ROCHESTER GAS AND ELECTRIC CORPORATION

R.E. GINNA NUCLEAR POWER PLANT

Revision 12 to:

Quality Assurance Program For
Station Operation

FIGURE 2-1

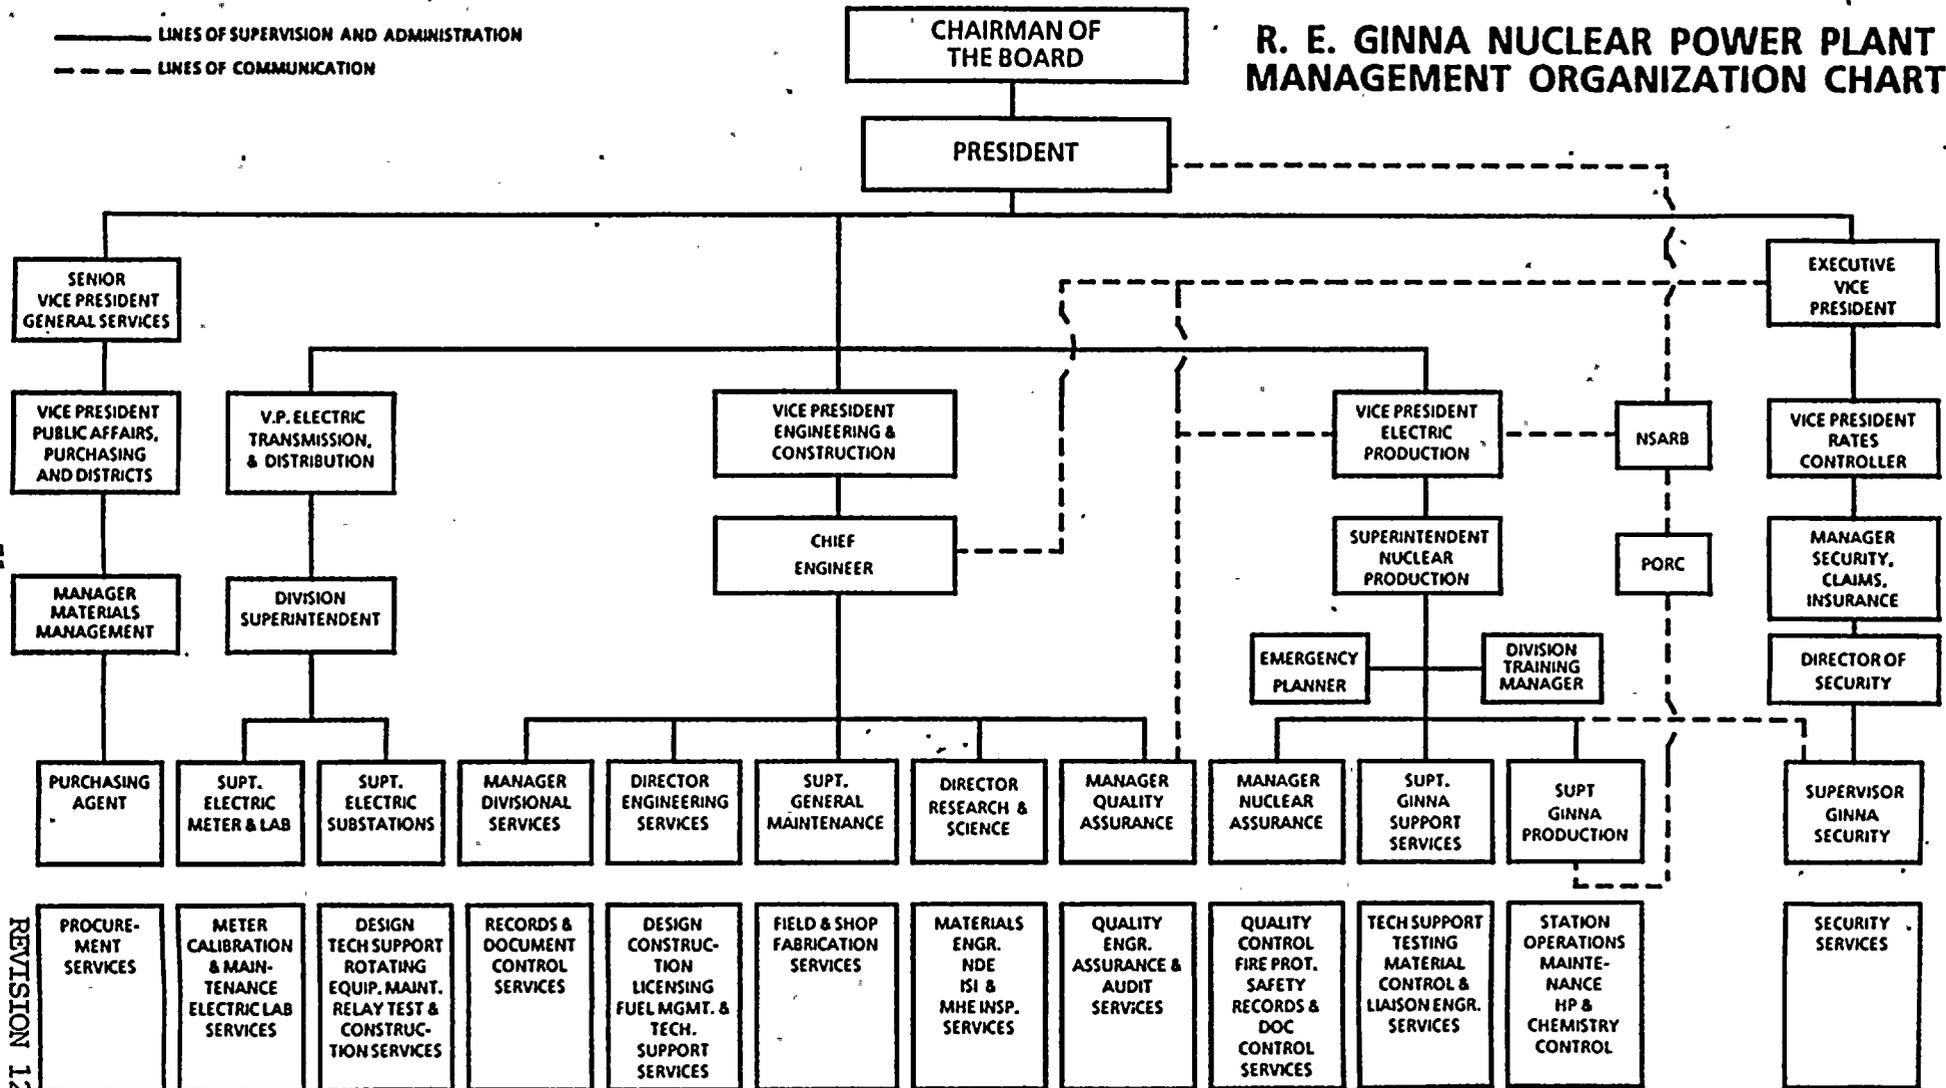
Revision 12 incorporates recent changes in the management Engineering, Ginna and General Maintenance organizations depicted in Figures 2-1, 2-3, 2-4 and 2-5, respectively. Figure 2-5 now reflects the organization of the Engineering Division which includes the departments of General Maintenance and Engineering previously depicted in Figures 2-4 and 2-5 respectively. Figure 2-4 now illustrates the Electric Transmission and Distribution organization. Additionally, minor clarifications have been made to the sections associated with supplier selection (Section 7), Quality Assurance Manager experience and responsibility (Section 2), and clarification of those reports forwarded to Quality Assurance and management described in Sections 15 and 16. The Table 1 listing of the various implementing procedures has also been revised to reflect the two added departments and related shift in responsibilities.
